AGENDA - FINAL
WAUKESHA COUNTY PARK AND PLANNING COMMISSION - Regular
Thursday, November 19, 2026 1:00 P.M. Room AC 255/259
Administration Center, 515 W. Moreland Blvd., Waukesha, WI 53188

- **1:00 p.m**. **Public Hearing for 2026 Amendments to the Comprehensive Development Plan for Waukesha County**

REQUEST TO AMEND THE COMPREHENSIVE DEVELOPMENT PLAN FOR WAUKESHA COUNTY

RE: November 19, 2026, Park and Planning Commission Meeting
Agenda Items 4
Applicant/Property Owner: Gideon Farms, LLC
Parcel Nos. MRTT0396.999.002 and MRTT 0396.999.006

SITE PLAN

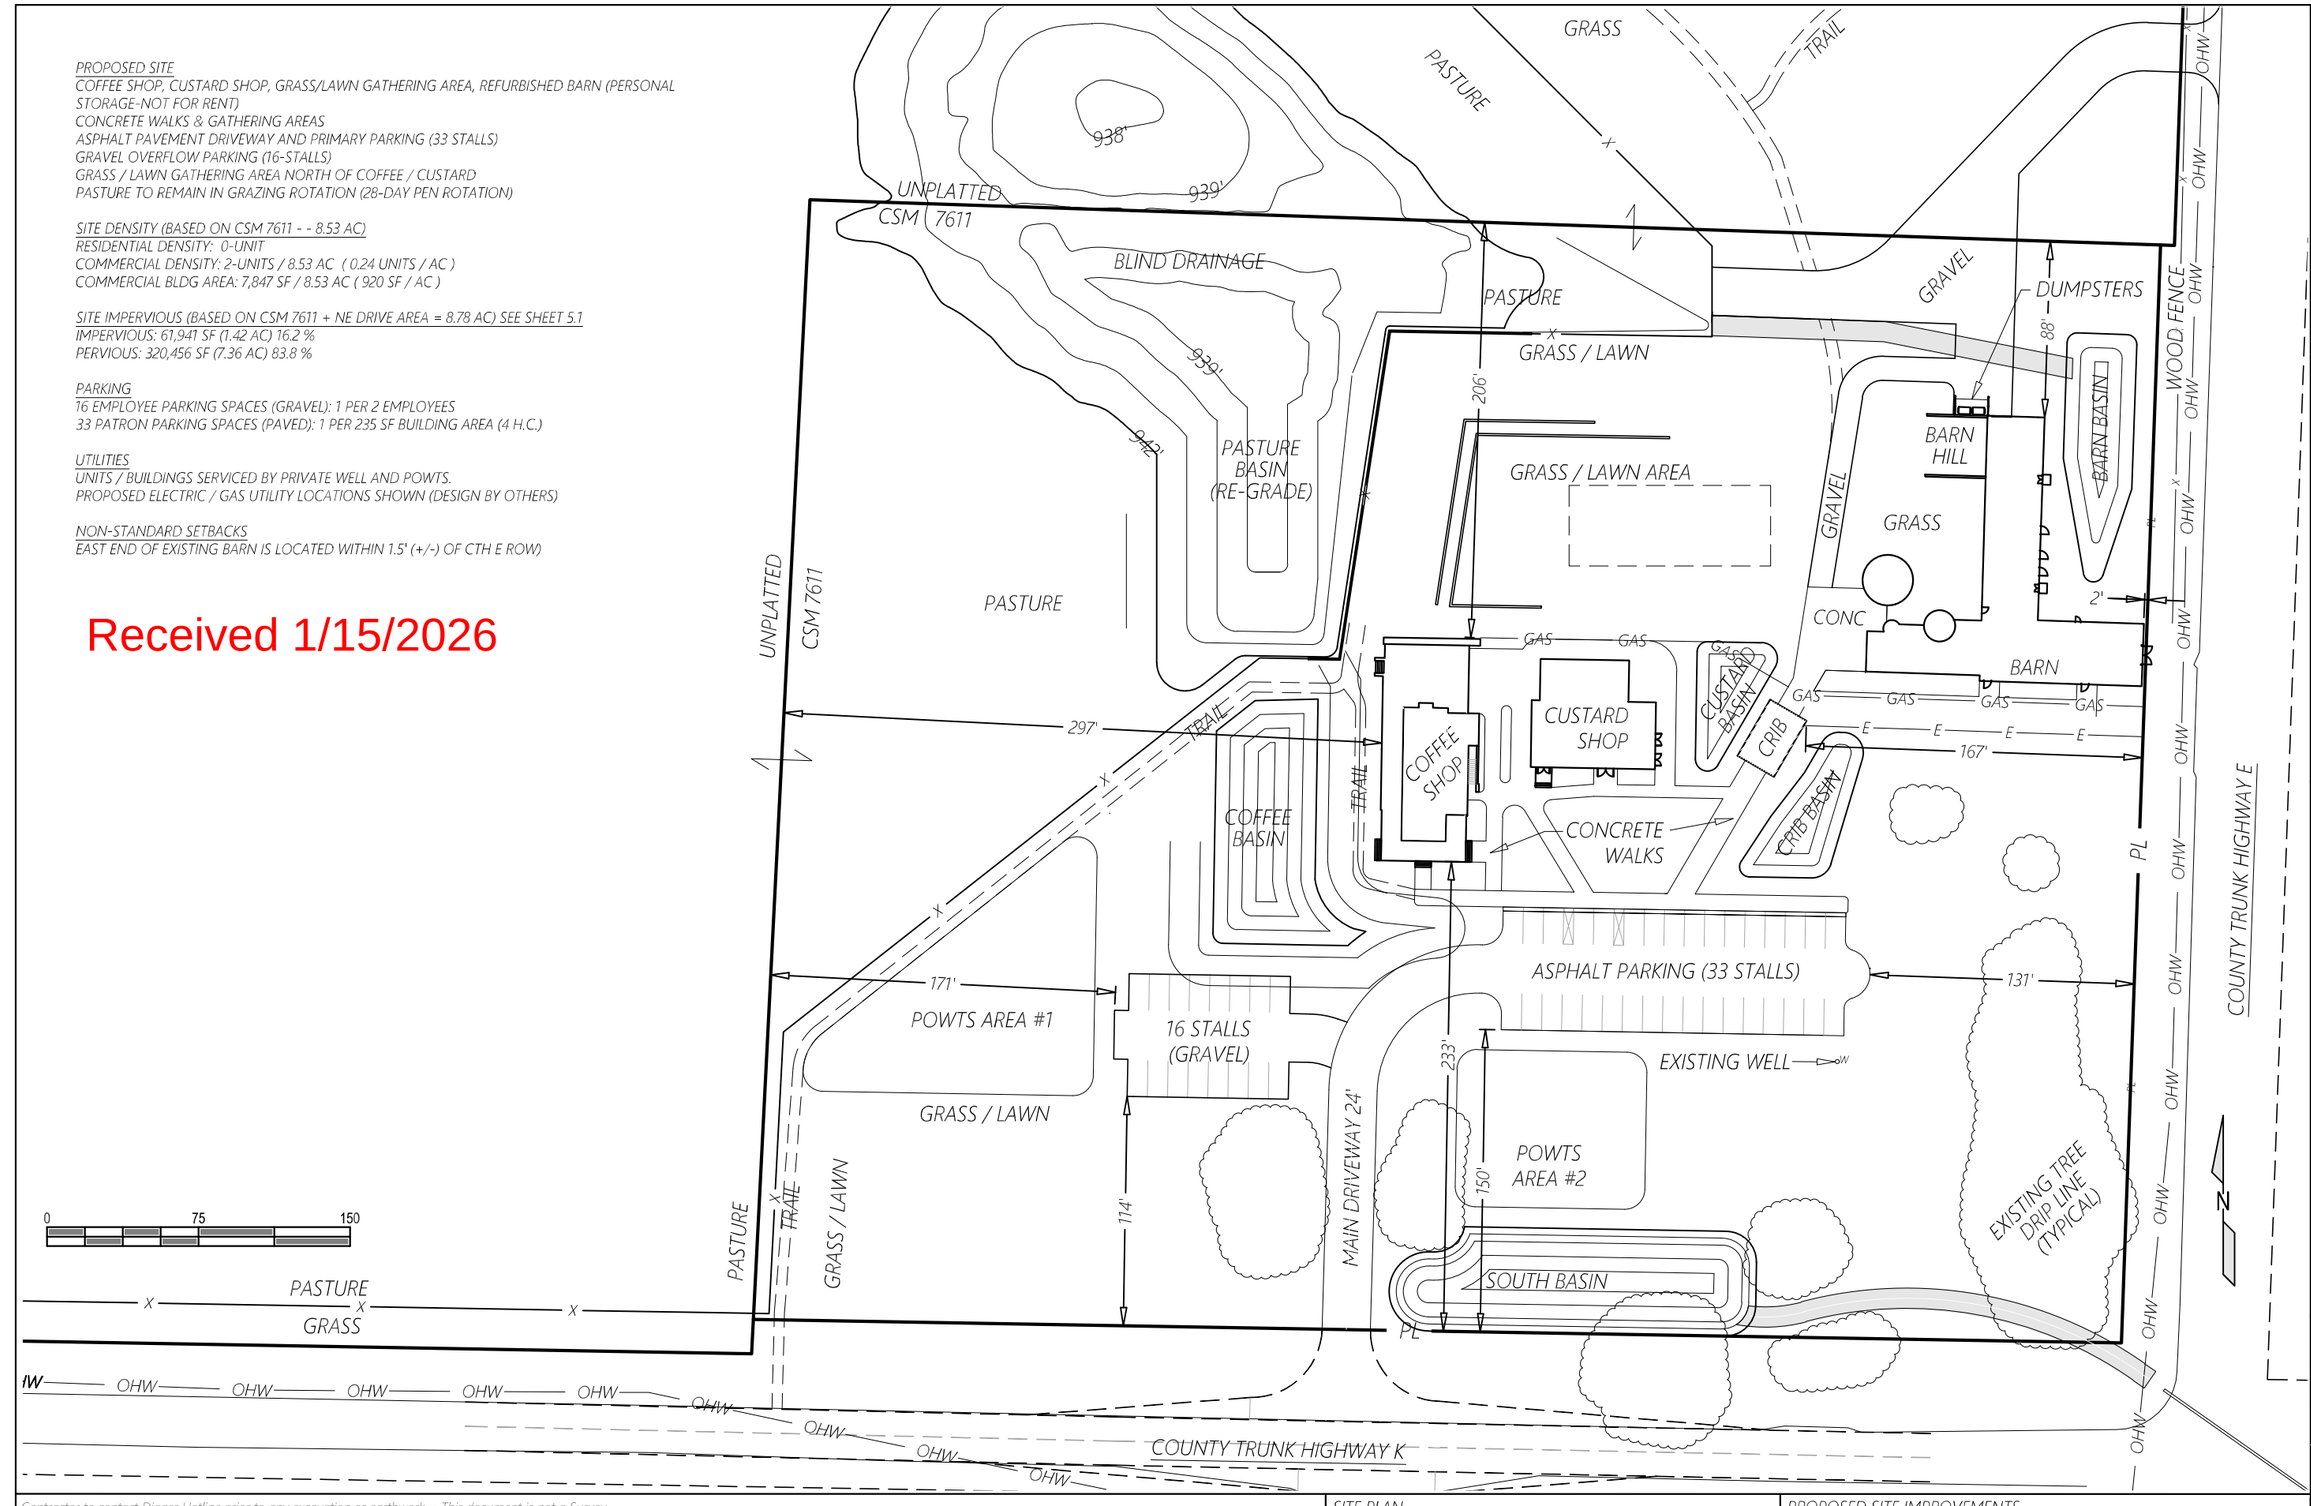
2. Agree to and establish a stormwater pond/stormwater management maintenance agreement. The submitted plans have the primary stormwater pond open to animal grazing. The Village's engineer recommends the pond should be fenced off to prevent livestock from entering the pond.

3. Pedestrian access crossing locations from both Swallow Elementary and Arrowhead to the Farm need to be controlled. The plans submitted do not have any crosswalks, walkways or any other safe travel routes for pedestrian foot access to the Property. Given that Arrowhead High School is across the street, the Village anticipates that a large portion of customers that will buy or consume treats and beverages at or take-away from the Property will be coming via foot from the high school and will need safe passage across the road to get there.
